**NGGM-PM-0033**

**Revision 54**

**Title: New Nuclear Plant Development Quality Assurance Program**  
**Description Topical Report**

**Harris Nuclear Power Plants Units 2 and 3**  
Docket Nos. 52-022 and 50-023

Figure II.1-1

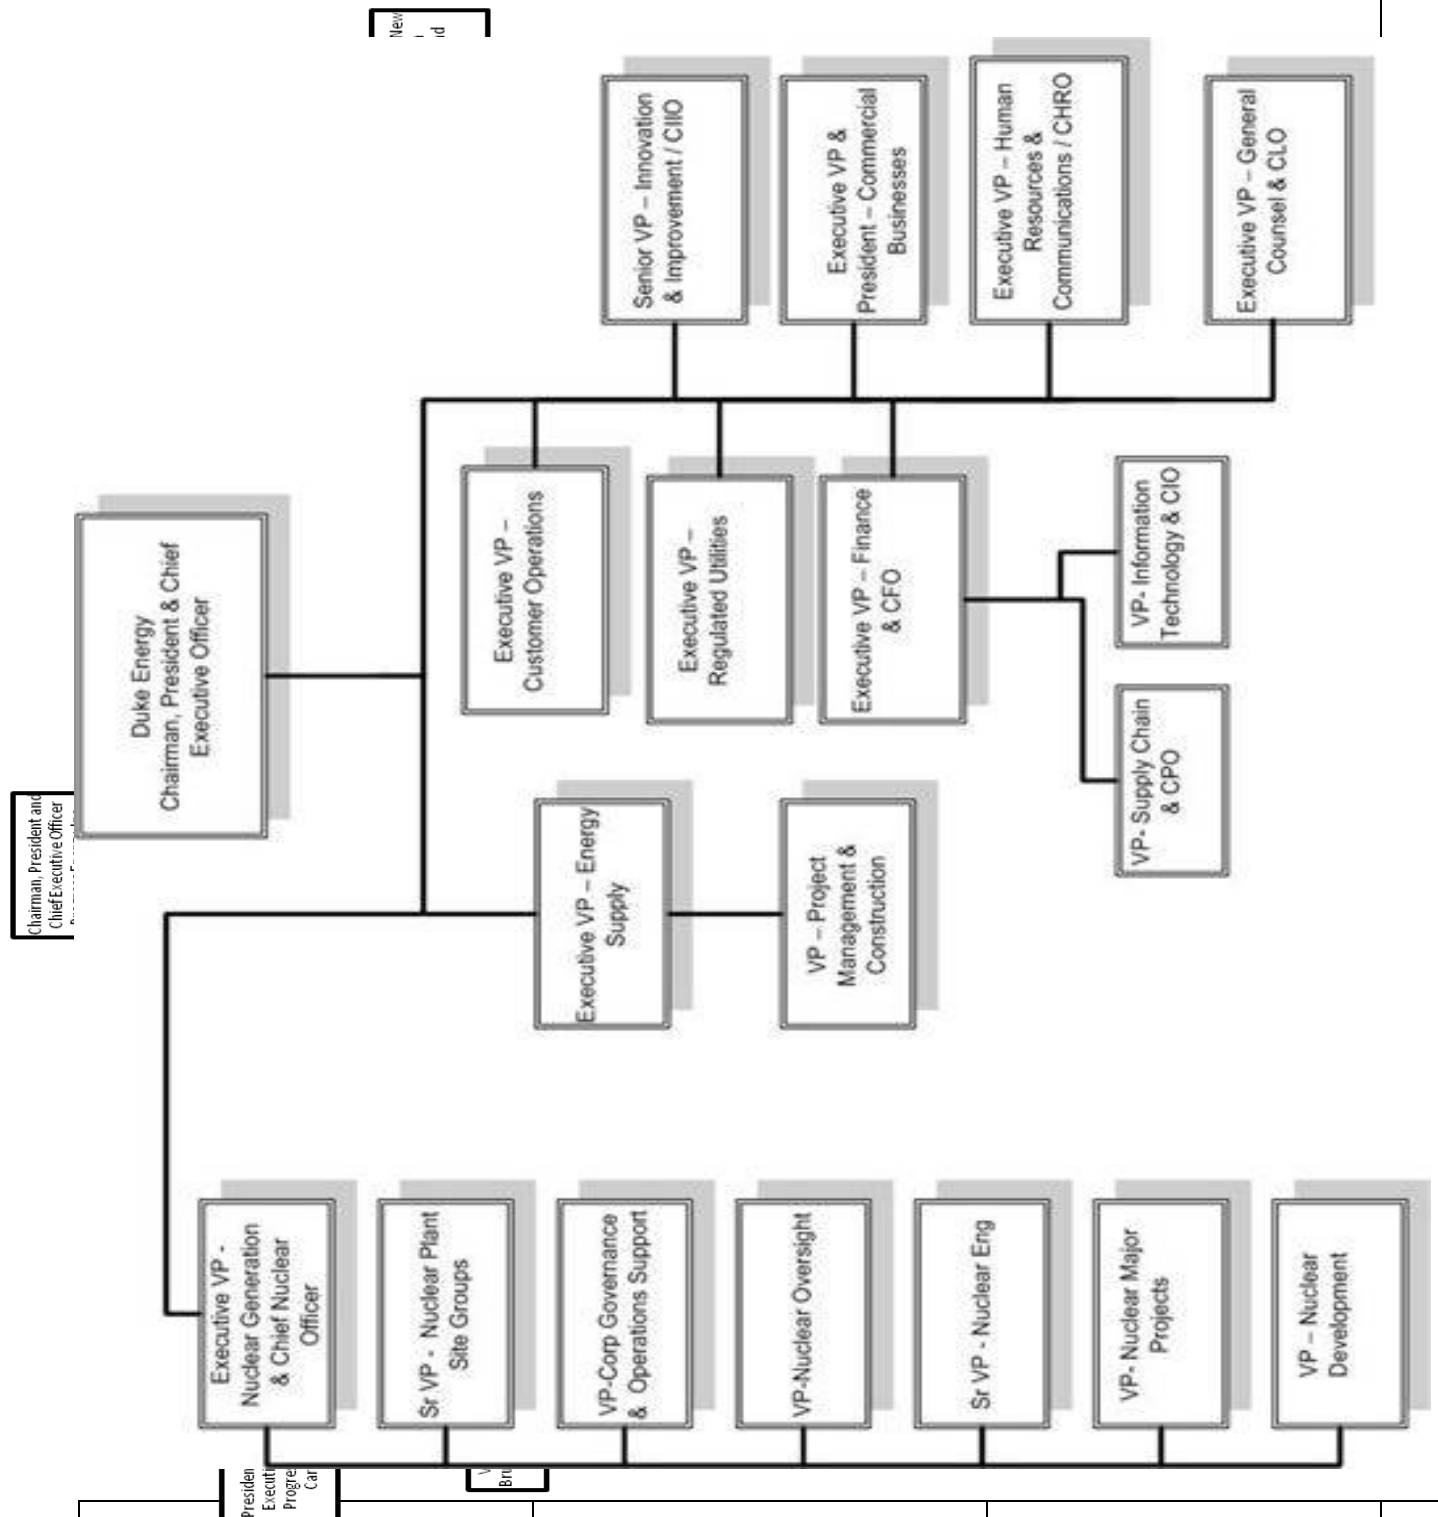
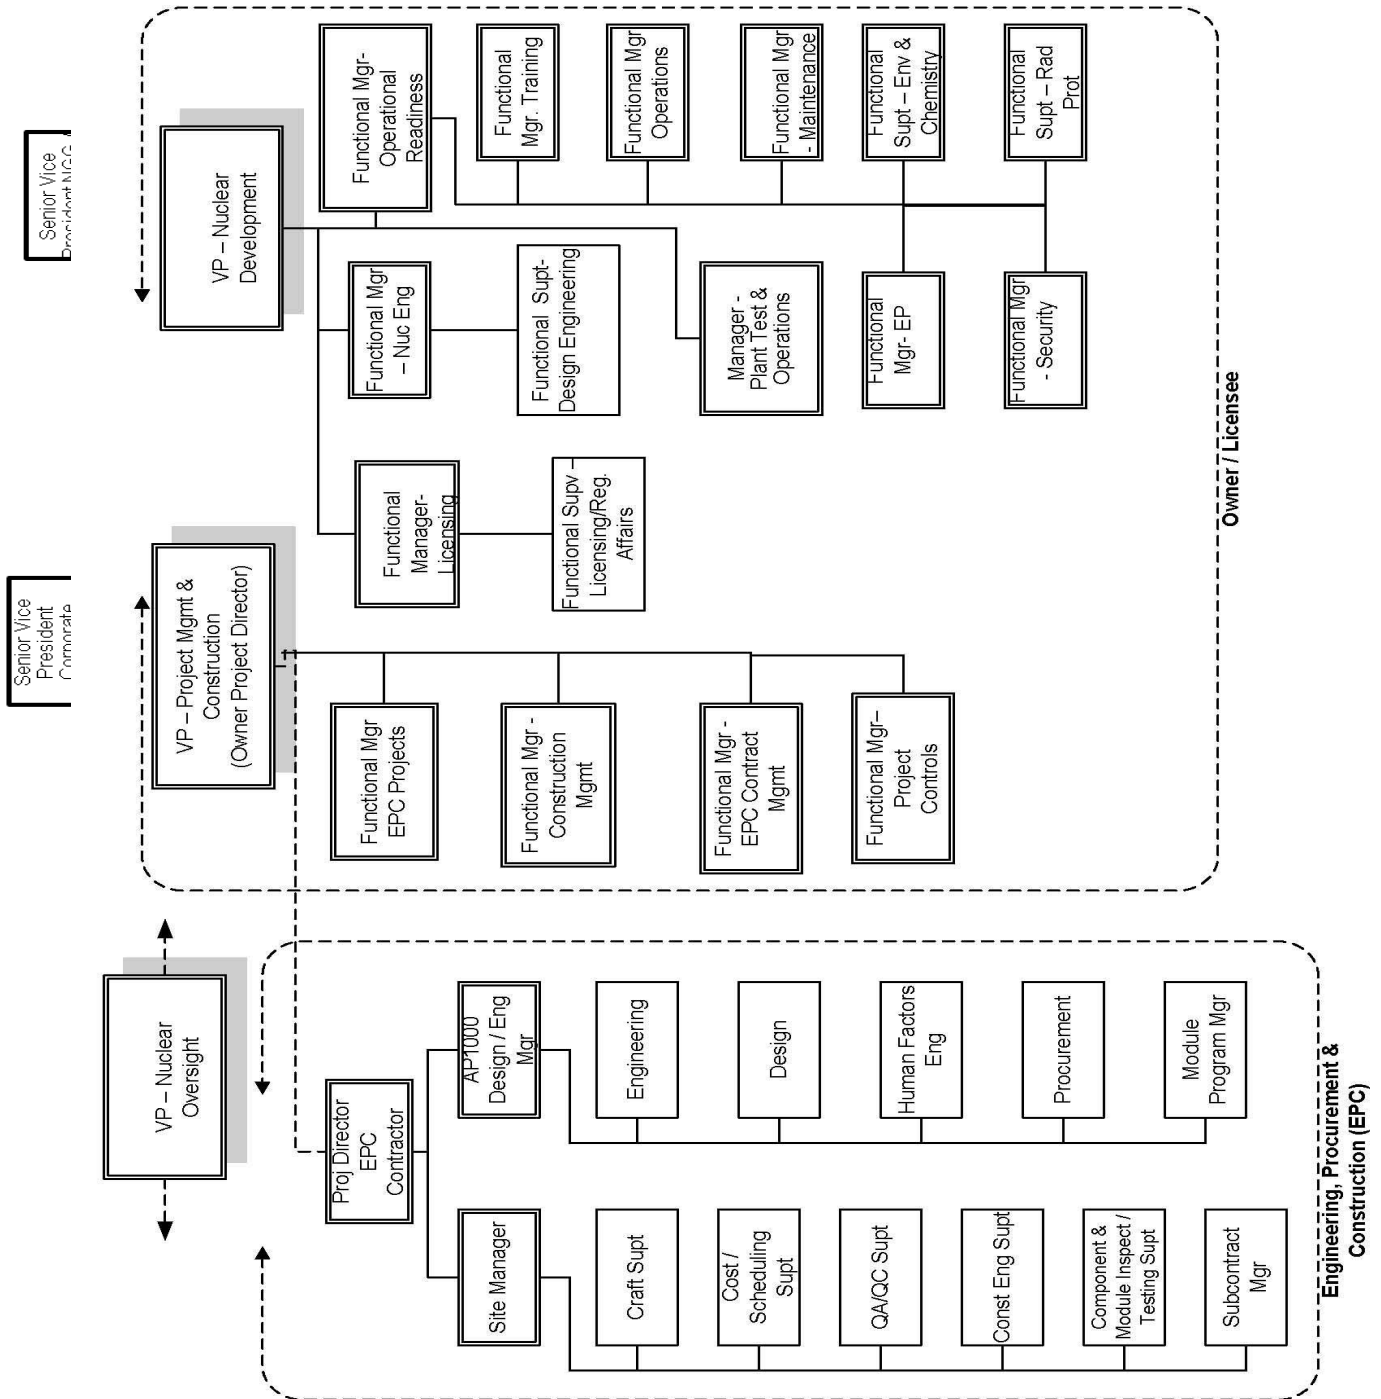
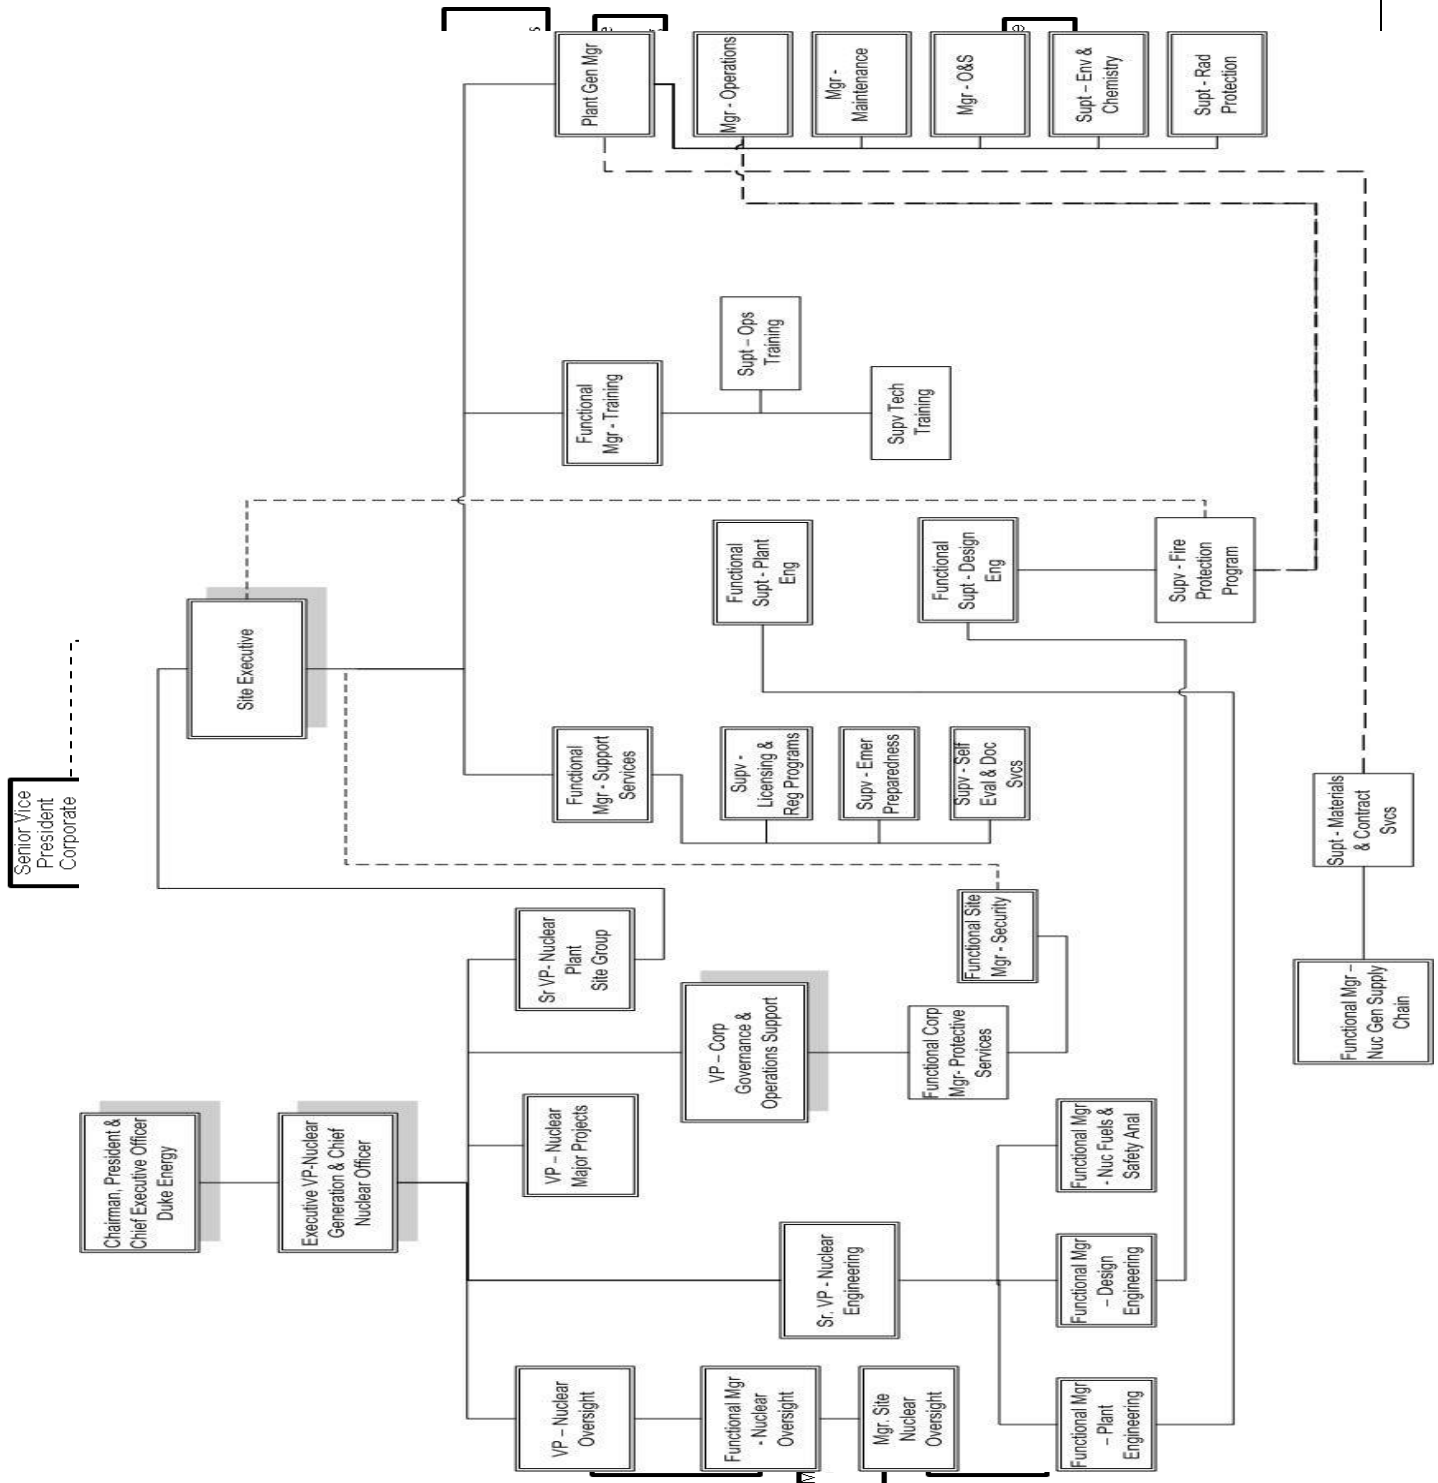
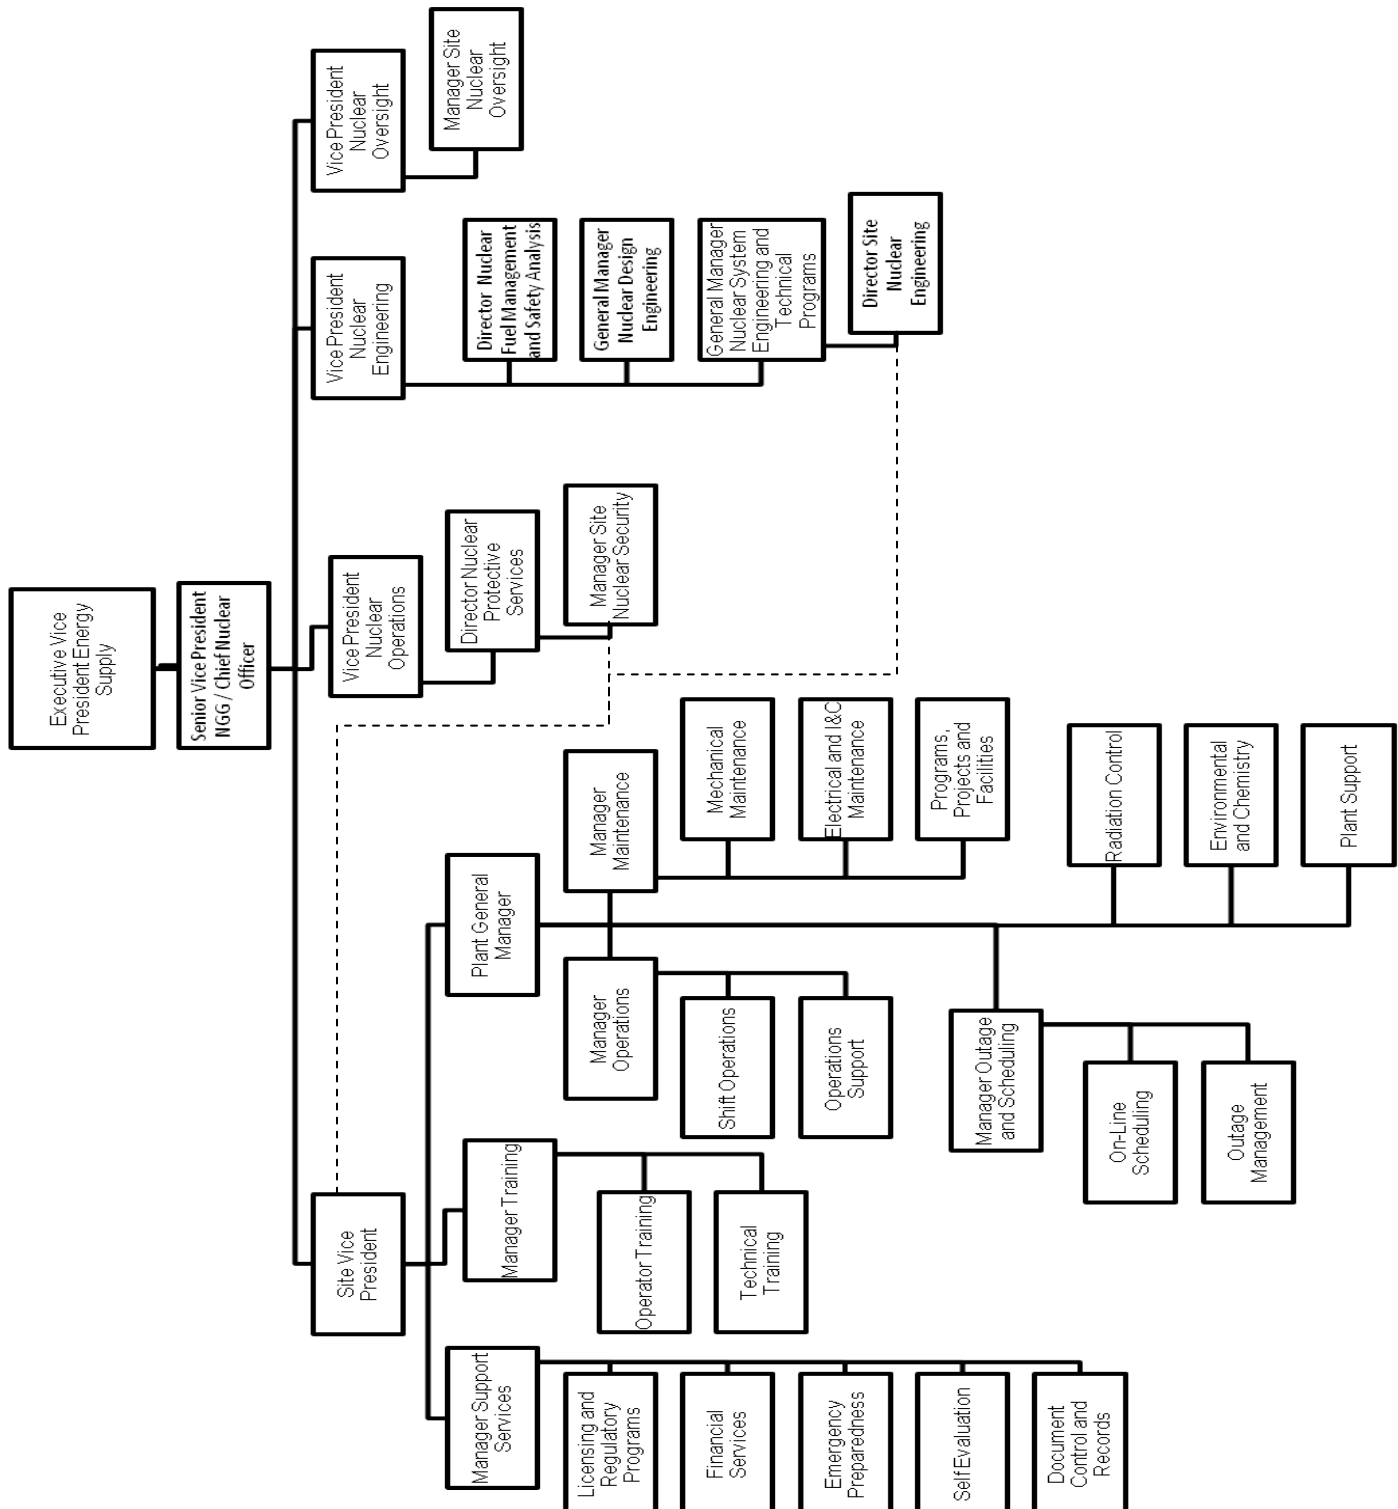
- Part II, Section 1.5 – 1.10 – Changed section numbering to reflect changes in section. No changes in section descriptions.
- Part II, Figures II.1-1, II.1-2, and II.1-3 – Revised figure to reflect new organizational structure and titles.

- ~~• Part II, Section 1.7, Changed CDG to CDIG.~~
- ~~• Figures II.1 1, II.1 2, II.1 3, and II.1 4 revised to reflect above noted changes in titles and reporting relationships.~~
